BID C1872C WATER CONSERVATION & LANDSCAPE PROJECT AT THE LIBERAL ARTS CAMPUS

ADDENDUM NO. 4

May 22, 2018

LANDSCAPE DEMOLITION PLAN

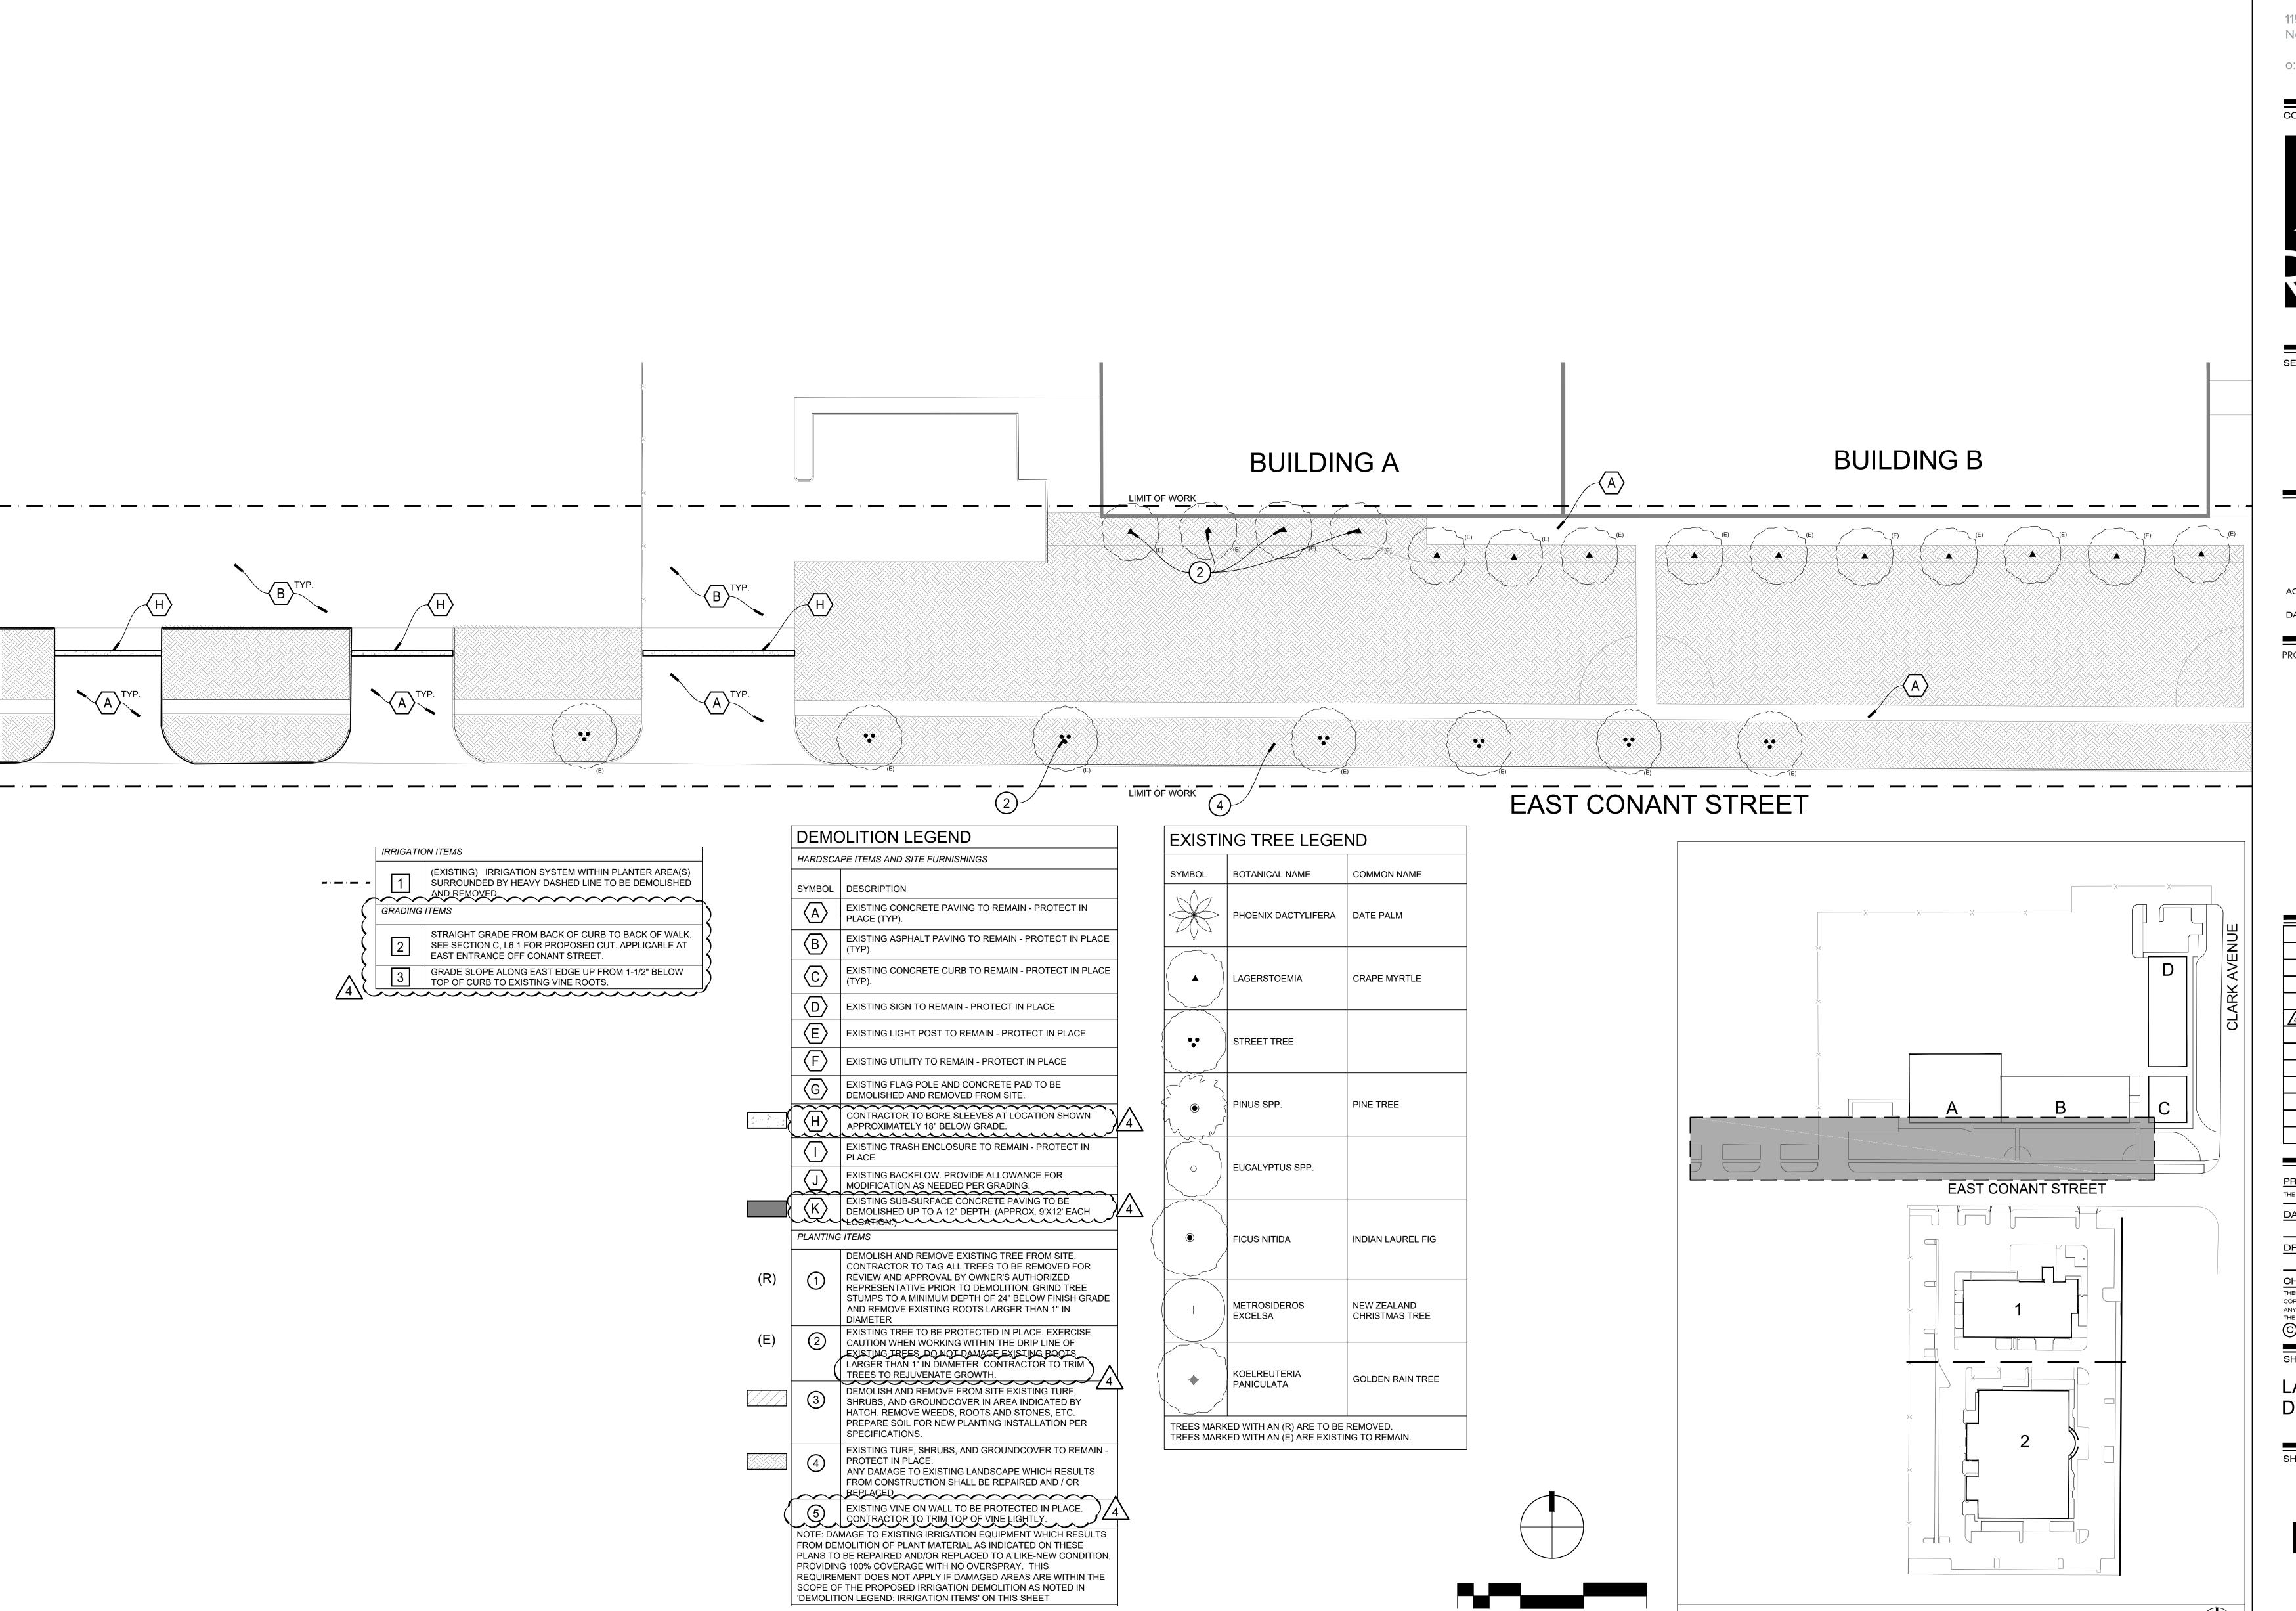
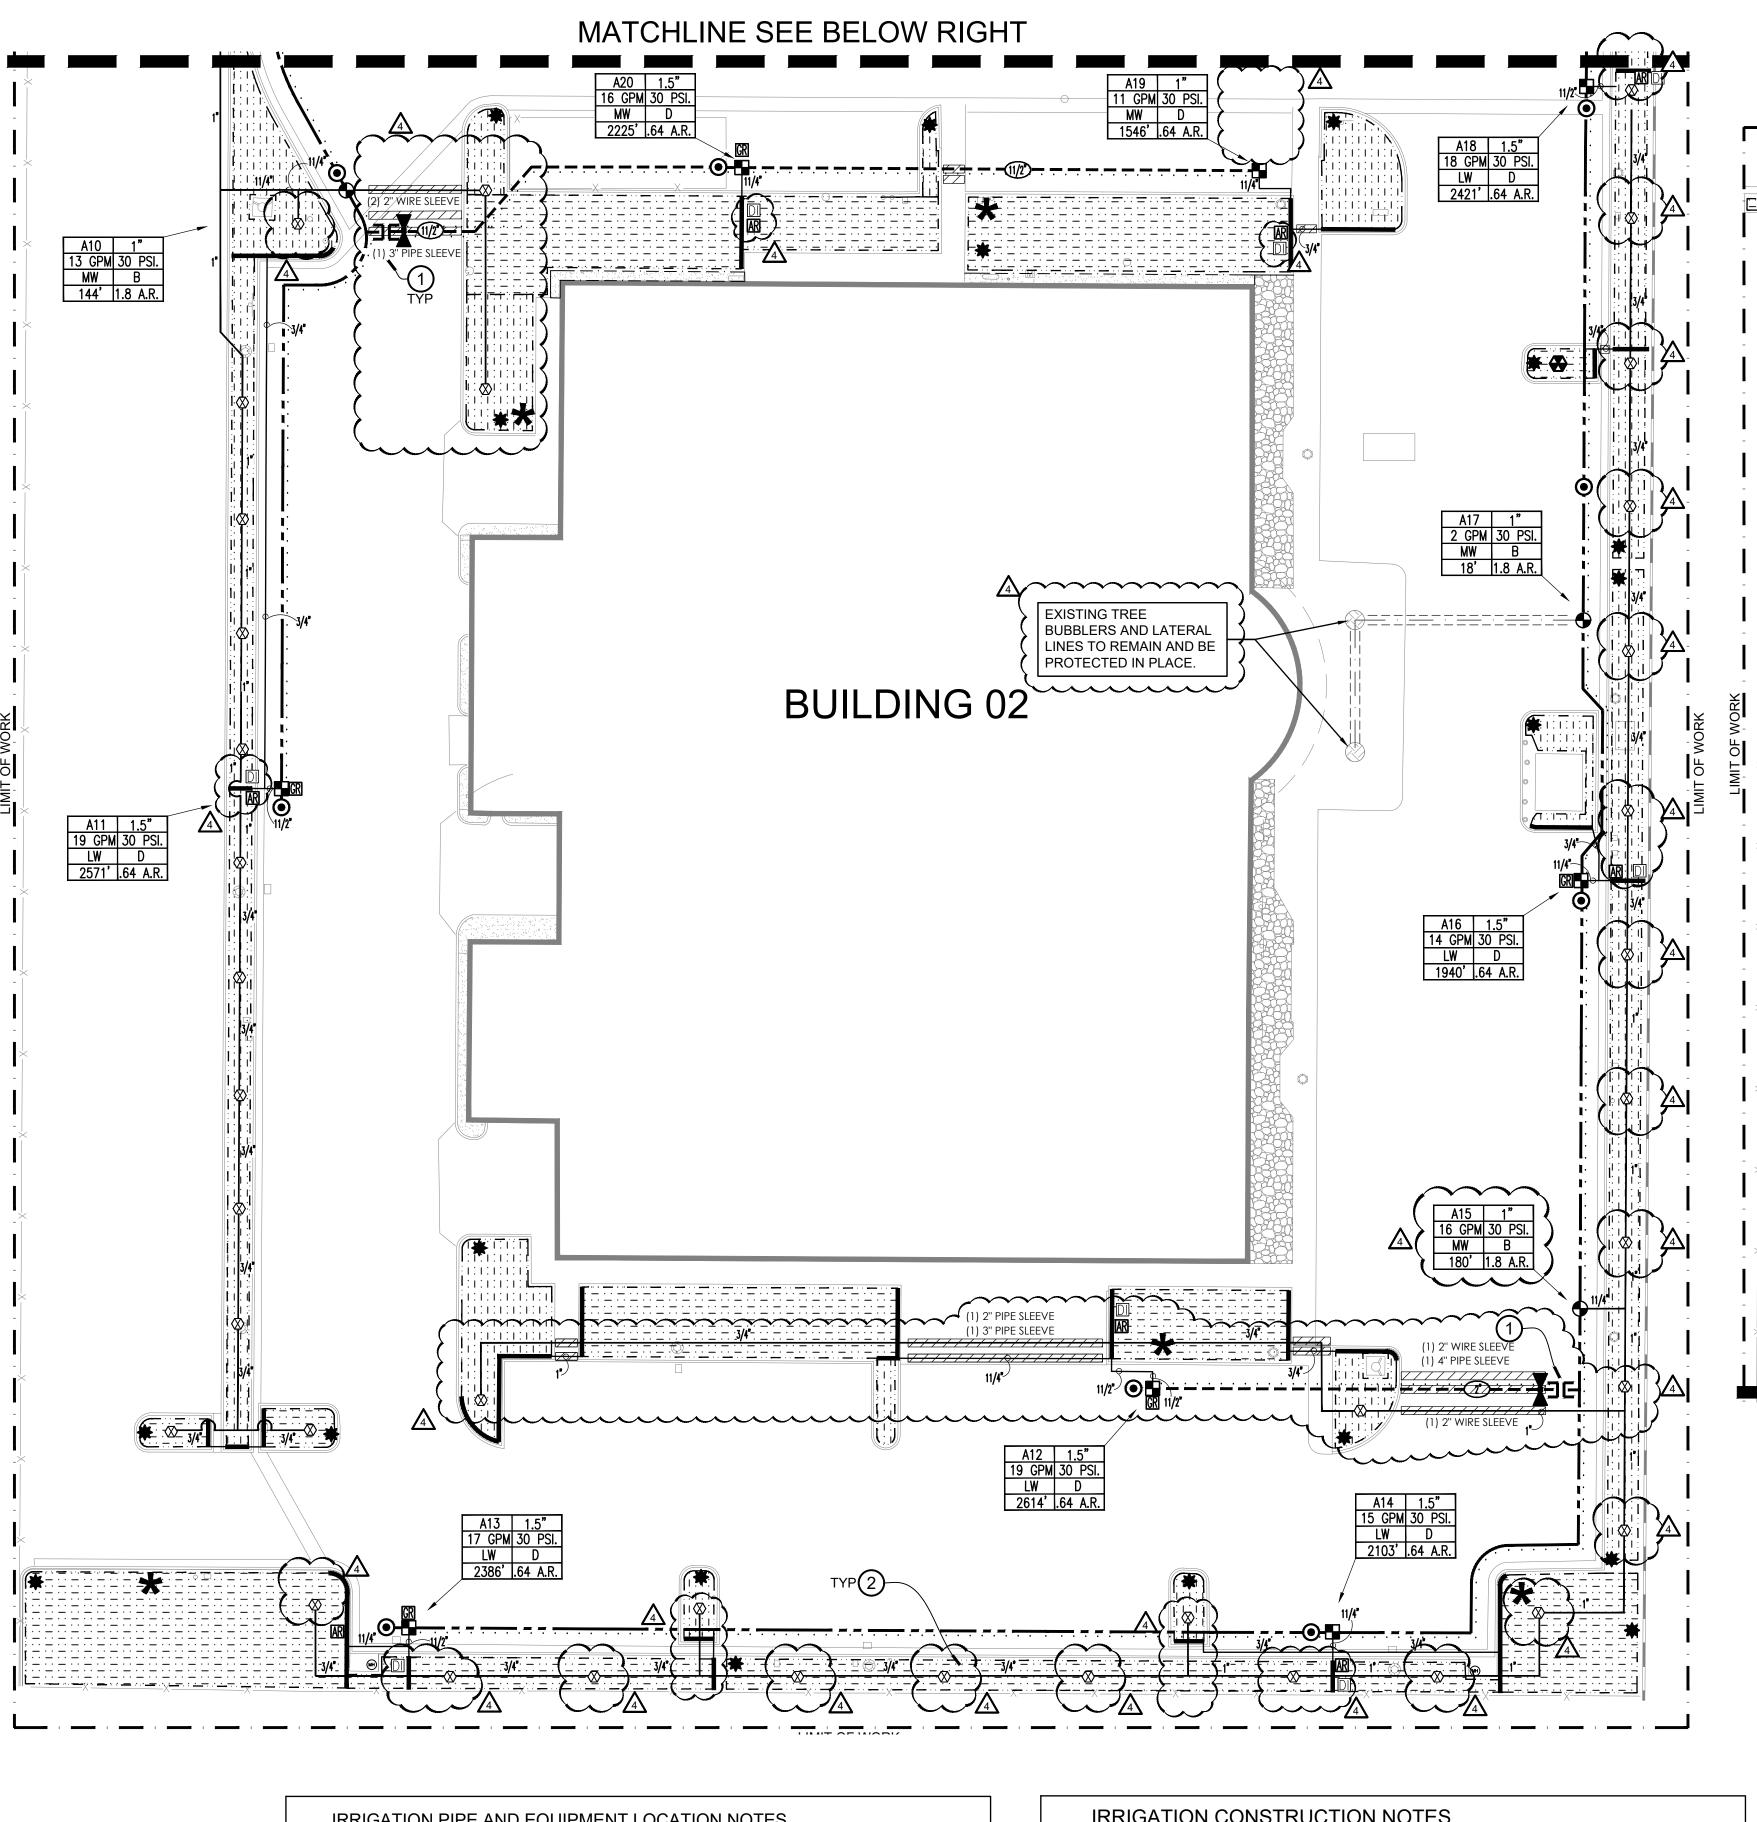
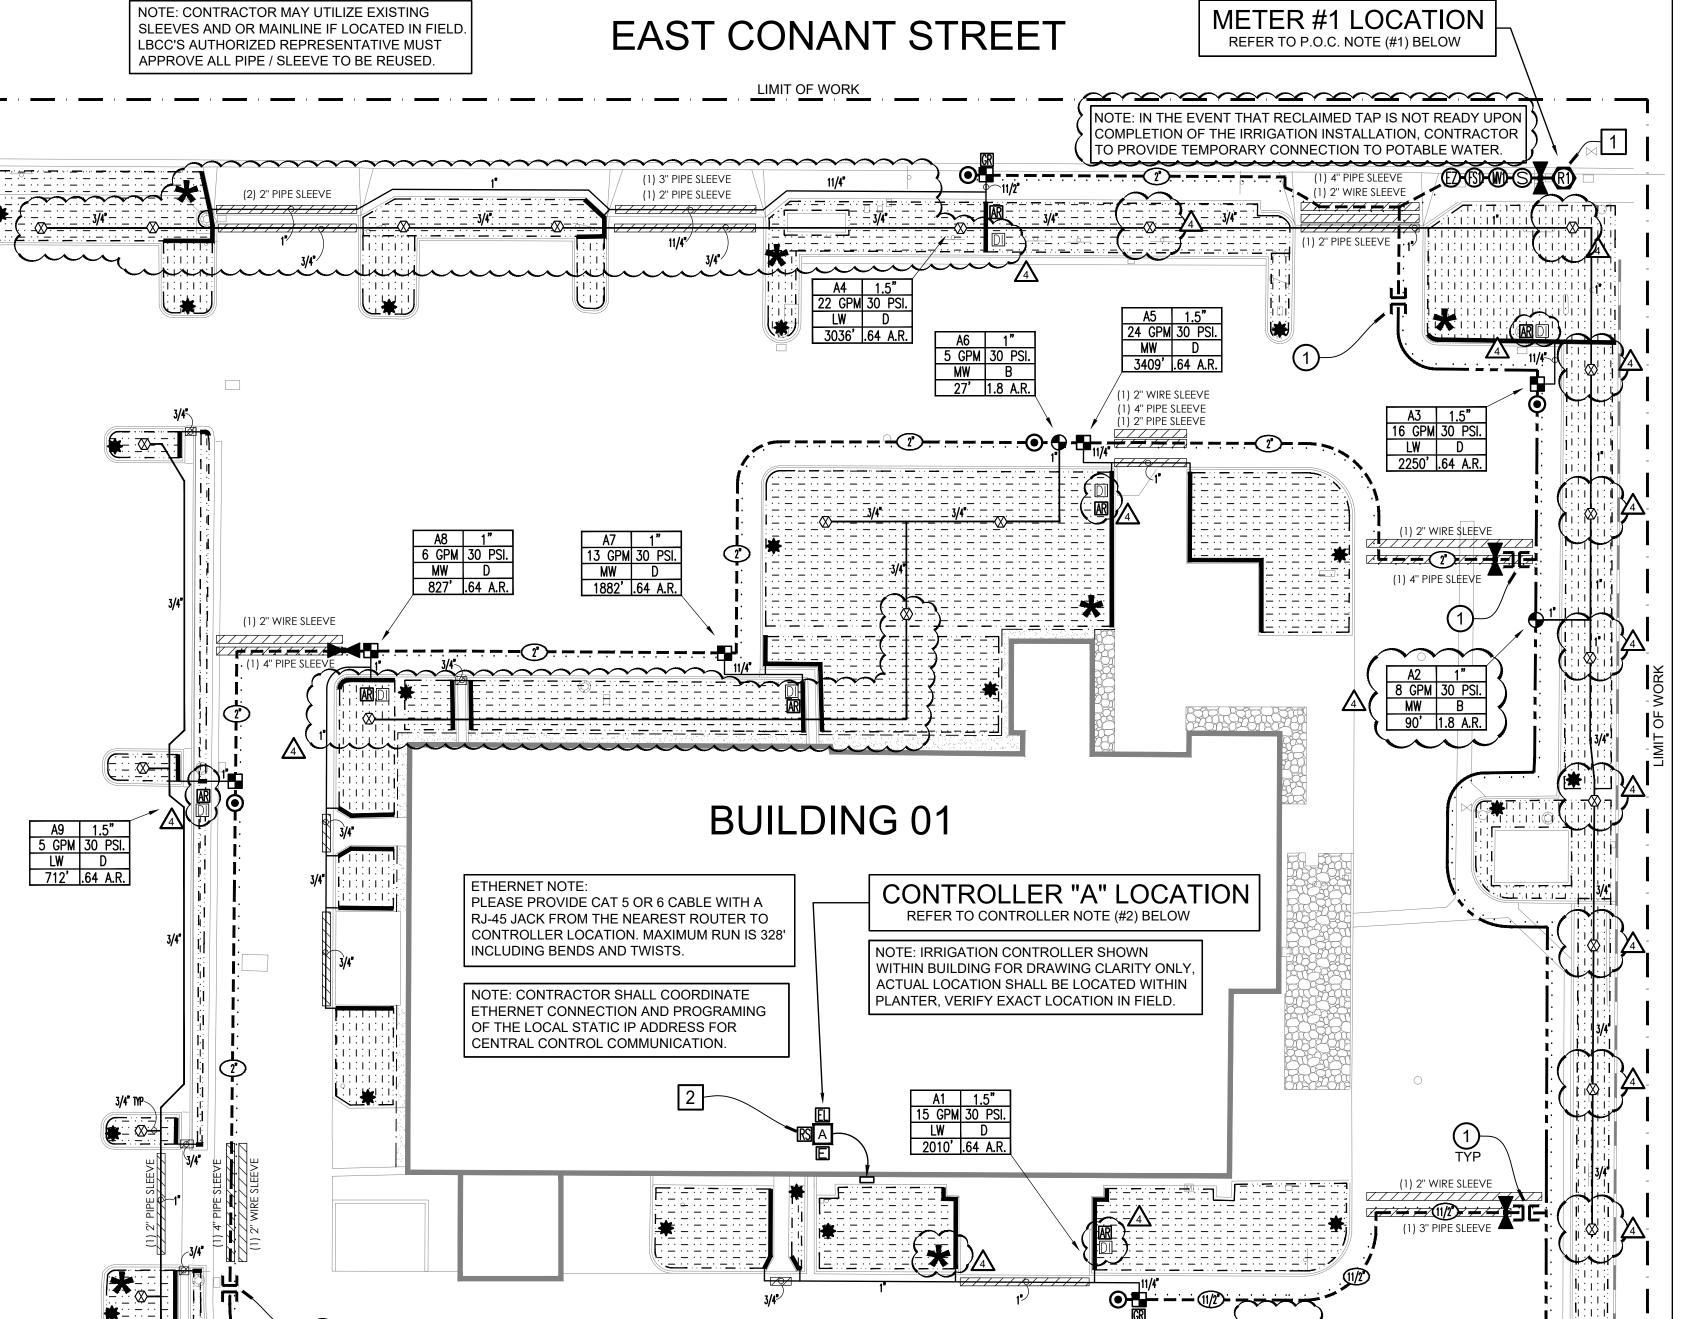
- 1. Plans L1.1; L1.2; L2.1; L2.2; L2.3; L3.1; L3.2; L4.1; L4.2: L5.1 and L 6.1 have been updated with increased amount of tree demolition, addition of new trees, and all associated irrigation.
- 2. Union fittings added to all valve boxes.
- 3. Increased work boundary to include the east side of Building Z.
- 4. Commscope certified contractor to provide and install CAT-6 data wiring from IDF rooms to irrigation controllers. Commscope certified contractor also to provide and install all data wiring in ³/₄ inch conduits.
